MIL-P-82436 (OS)
Amendment 3
4 April 1969
Superseding
Amendment 2
29 October 1968

MILITARY SPECIFICATION

PUMP, FUEL

This amendment forms a part of Military Specification MIL-P-82436(OS) of 10 May 1966 and has been approved by the Naval Ordnance Systems Command, Department of the Navy

Figure 1. Support Frame

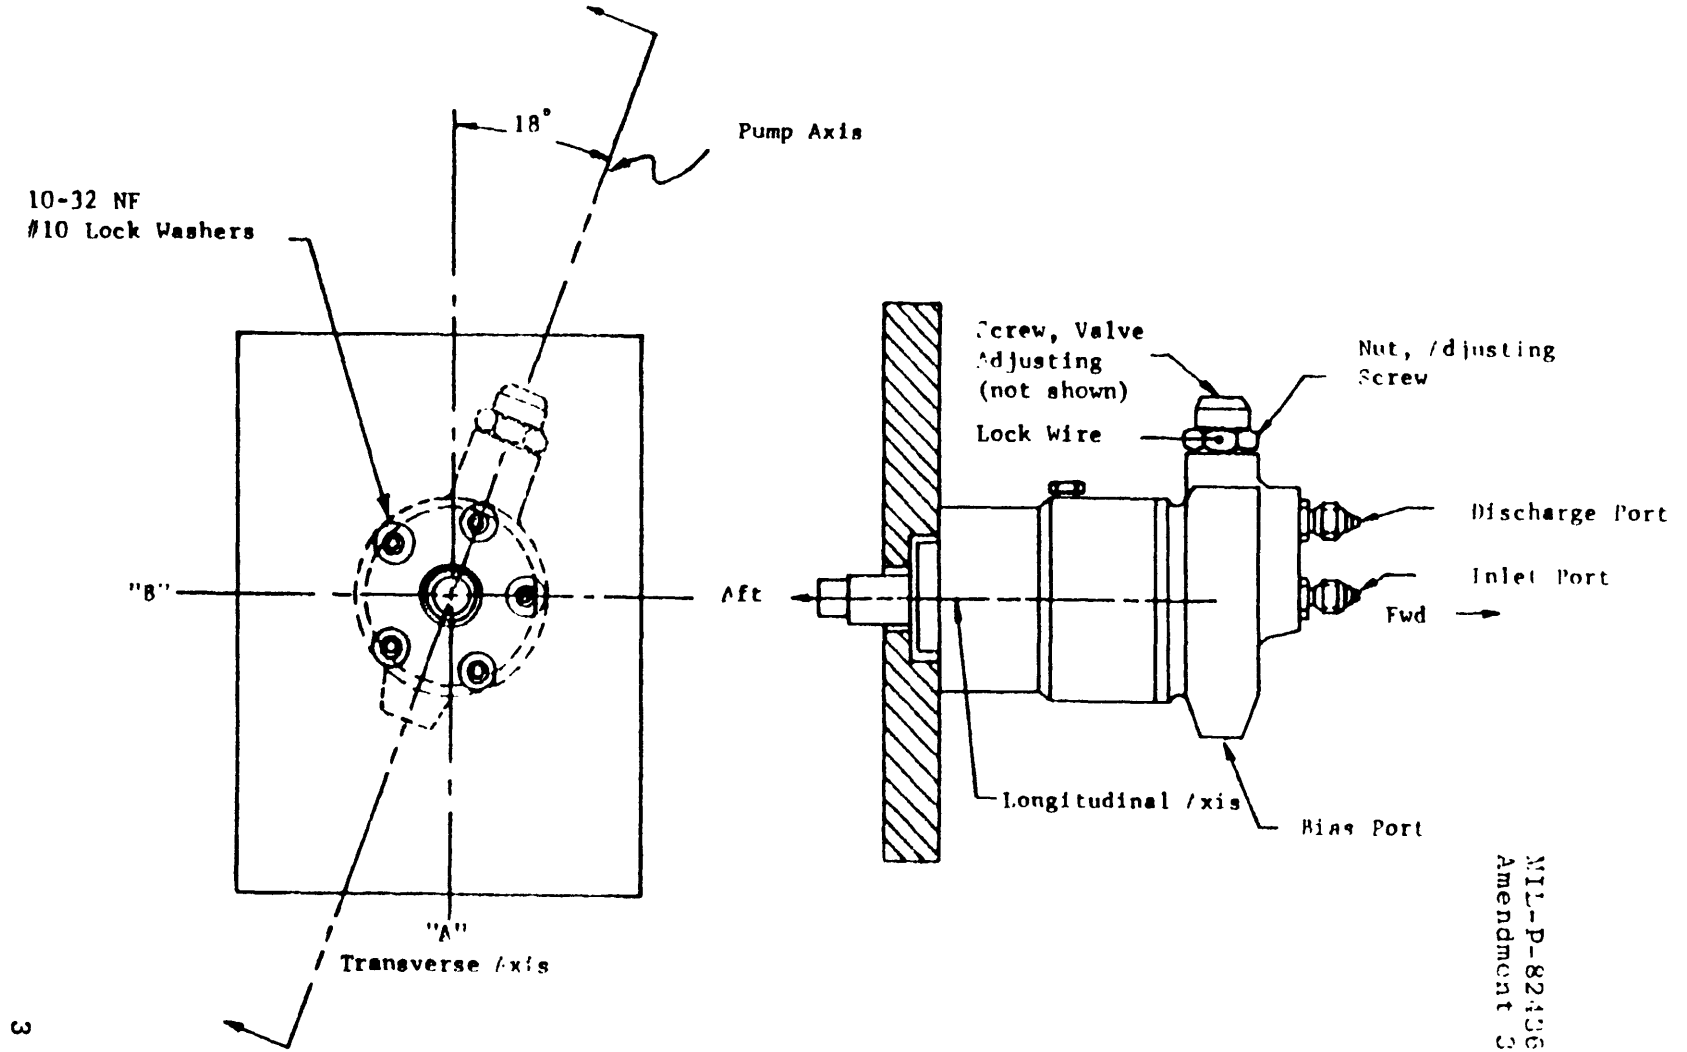
Page 27. Replace Figure 1 with new Figure 1, attached.
